Product Change Notice (PCN)

PCN Number: PCN-0456805R-01

Product(s) Affected: MJ-2506N

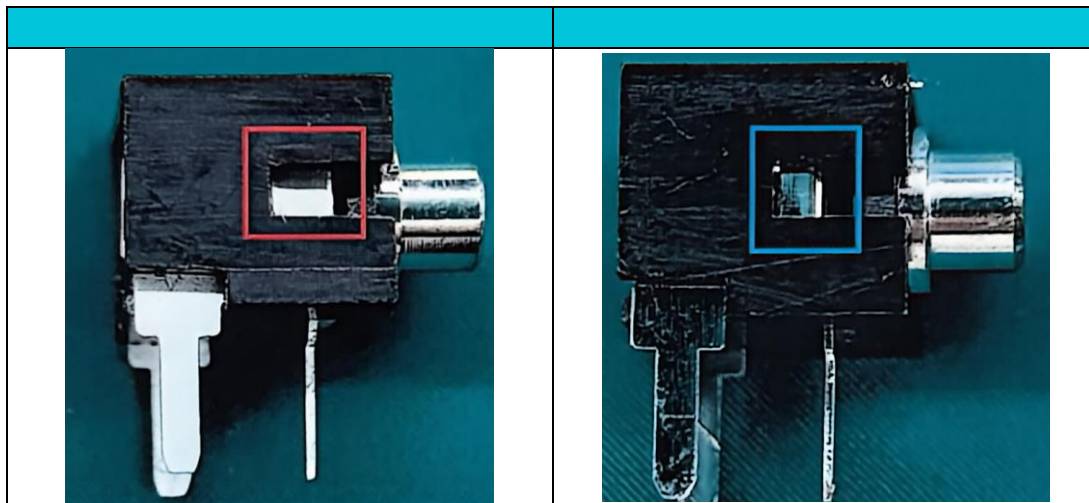
Description of Change: *Internal Change, not marked on the published product drawing. Increasing the spacing between the contact spring and the copper sleeve.*
